Unificazione pompe acqua 24-1071/ PA1071/ 101071 con 24-1072/PA1072/101072 Unification water pumps 24-1071/ PA1071/ 101071 with 24-1072/PA1072/101072

24-1071
(24-1358 with backhousing)

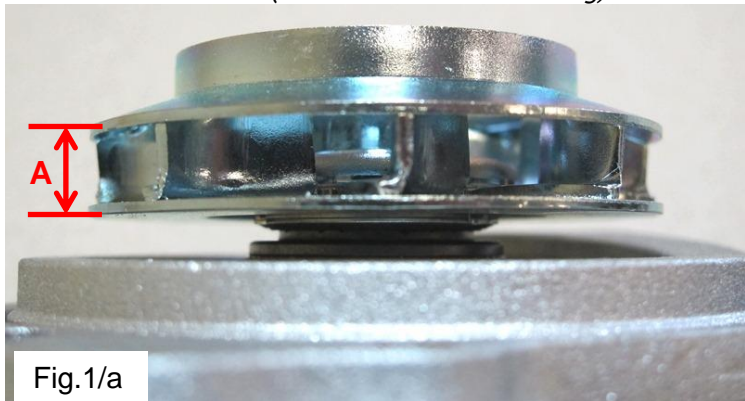
In the pictures below, we highlight the difference between the two Metelli water pumps which concerns only the impeller geometry:

- *Water pump 24-1071 (24-1358 version with backhousing), lower impeller (measure A)*
- *Water pump 24-1072 (24-1359 version with backhousing), higher impeller (measure A)*

Obviously, the unification has been done on the water pump with the most performing impeller, so as to ensure the correct thermal management of the engine on all the applications. Below are some graphs extracted from the comparative performance test between our water pump's impeller 24-1072 and the OE water pumps' impellers
